FIVE ESTUARIES OFFSHORE WIND FARM

10.4.1 APPLICANT RESPONSE TO NATURAL ENGLAND RELEVANT REPRESENTATION

Application Reference:	EN010115
Application Document Number:	10.4.1
Pursuant to:	Planning Act 2008 – Section 89(3)
EcoDoc Number:	005337385-01
Date:	October 2024

Figure 3.1 Density of Red-Throated Diver and number of detections per segment in February 2018 (Survey 2).

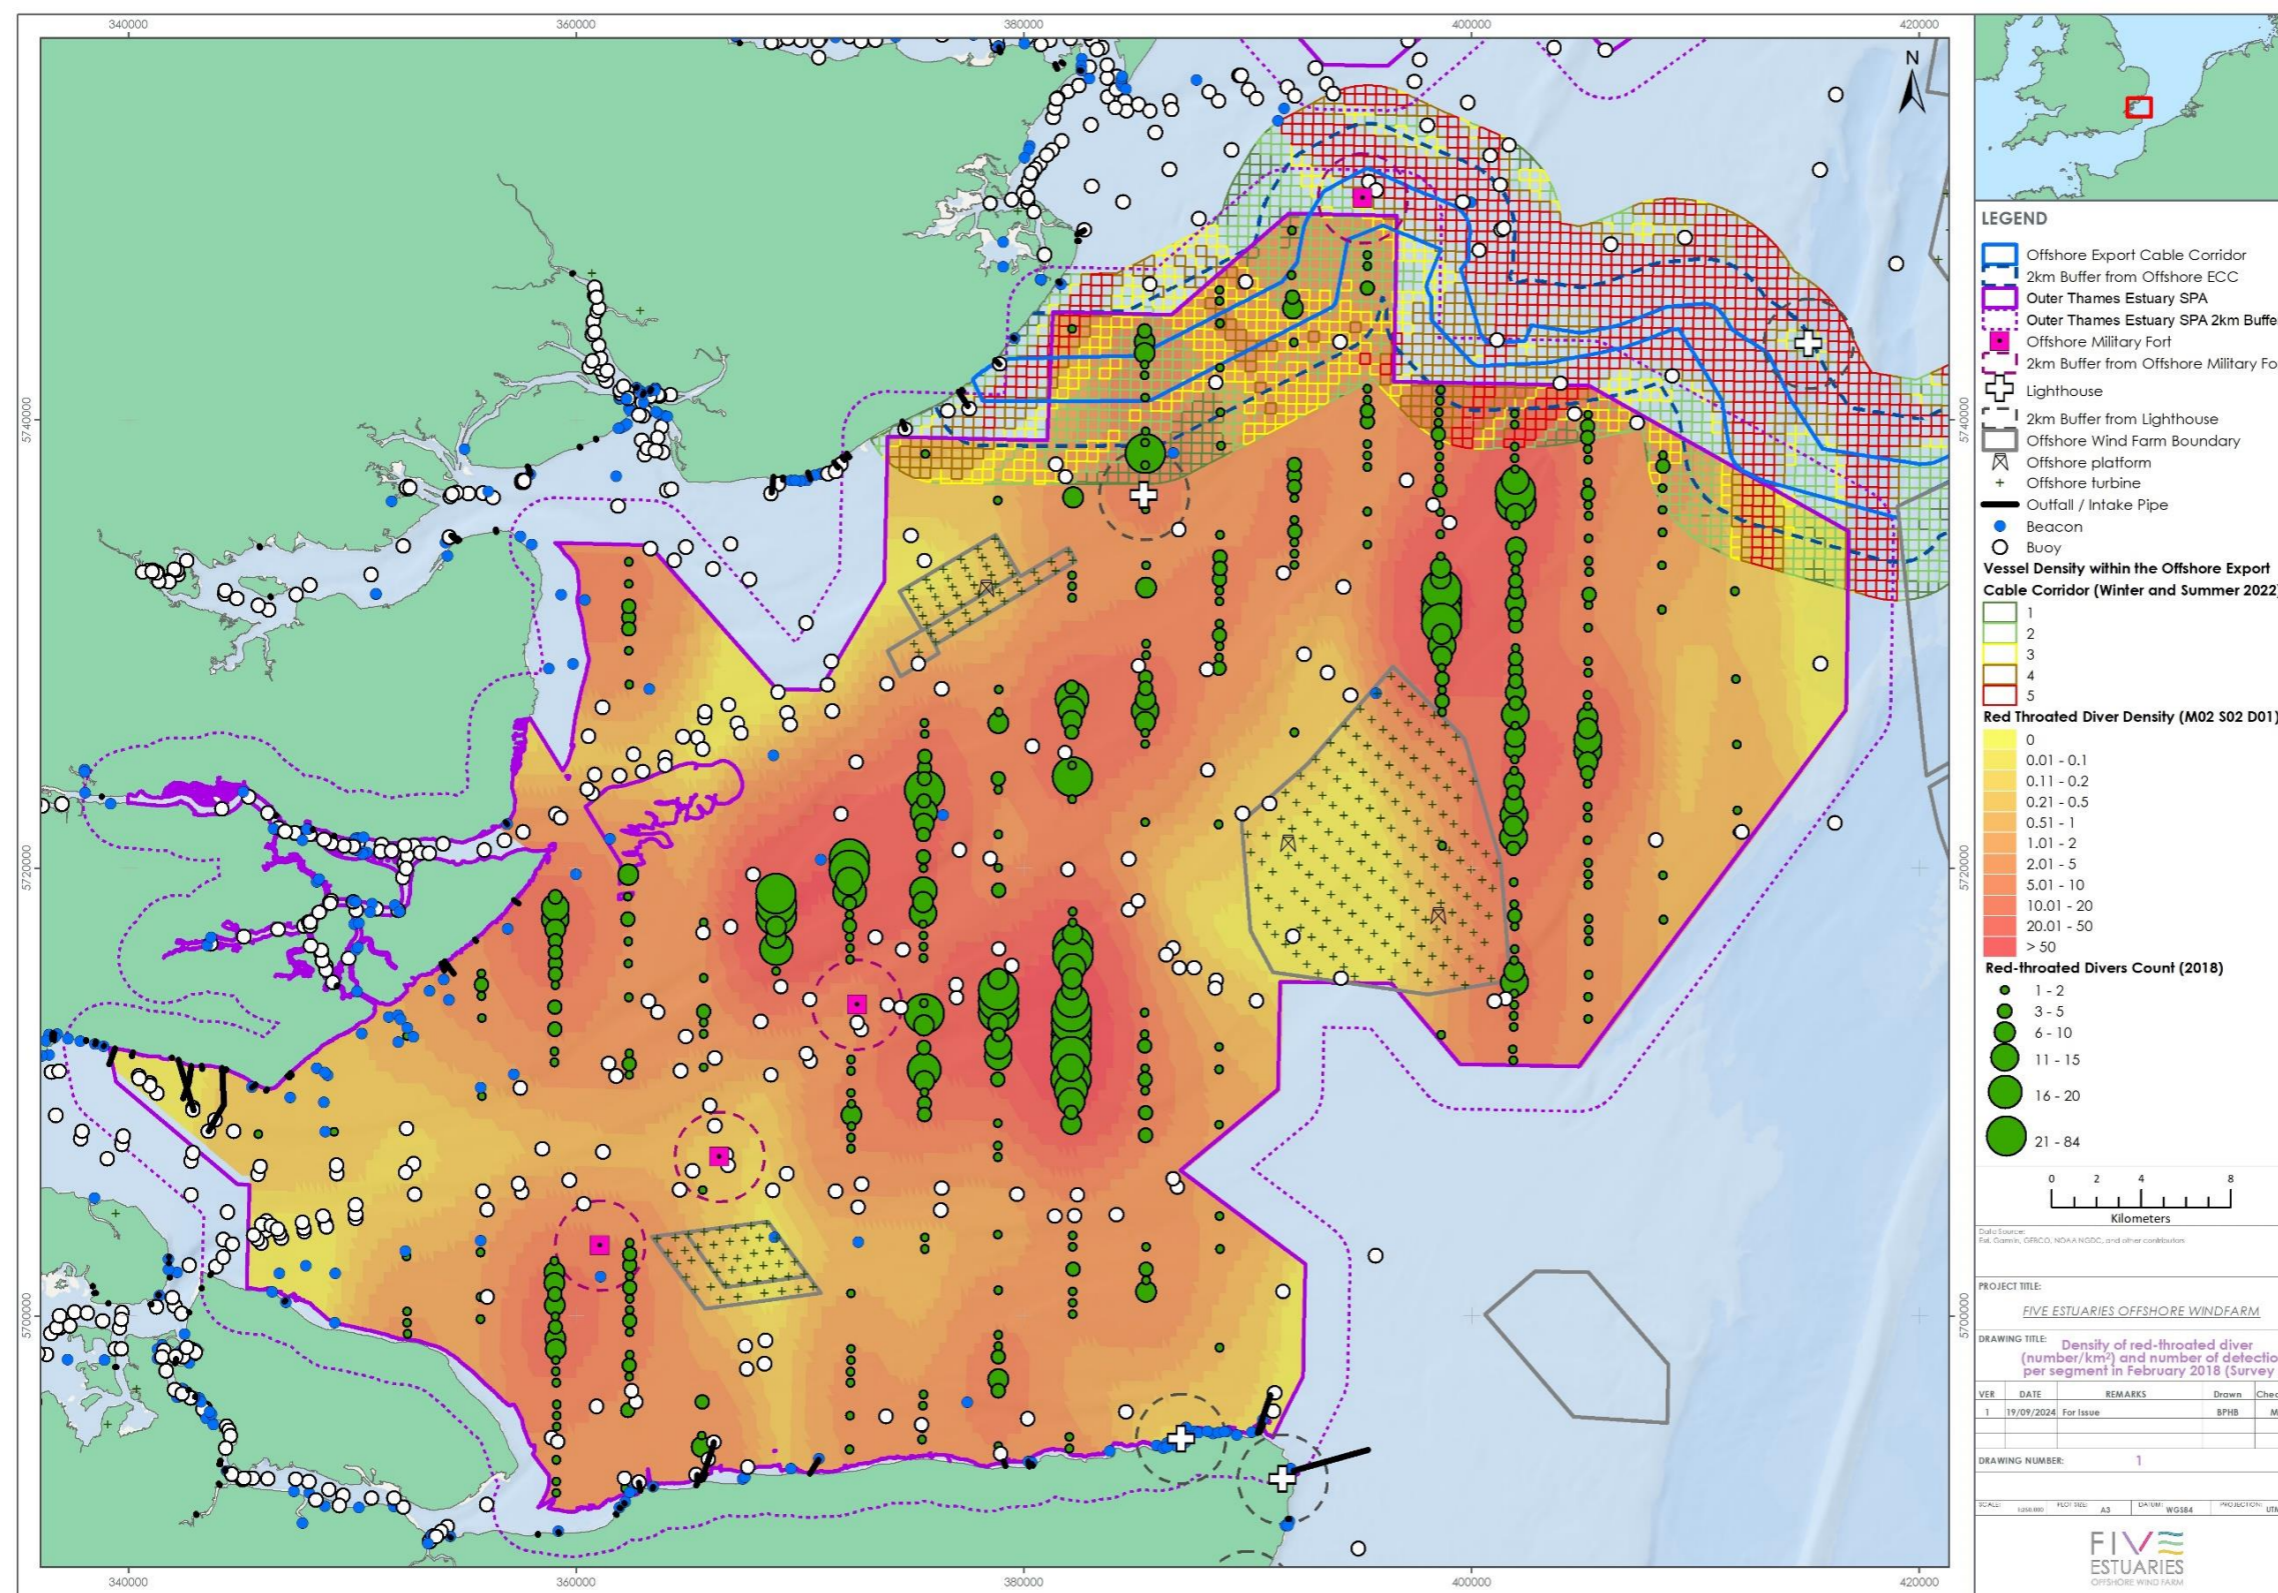
Ref	Relevant Representation comment	Natural England's Recommendations to Resolve Issues	Applicant's Response
	<p>England considers that the conservation objective of concern in this context is not RTD abundance but the availability of unimpacted habitat in the SPA and maintenance of the birds' distribution.</p>	<p>SPA +2km buffer be undertaken outside the seasonal restricted period during the Construction and Decommissioning (C&D) of the export cable (EC) and follow Natural England best practice guidelines on vessel movements during all other phases of the development for both the EC and array.</p>	<p>etc is entirely within normal shipping activity variability and would therefore not increase disturbance in any meaningful way.</p> <p>The Applicant has identified cable laying within the SPA as having greater potential for disturbance, and that is why it has committed to a timing restriction for that activity in that area only. Any other works in the ECC outside the SPA would be largely indistinguishable from background traffic given the already high density and would not lead to additional impacts on the SPA. See Appendix A:</p> <p>Figure 3.1</p>
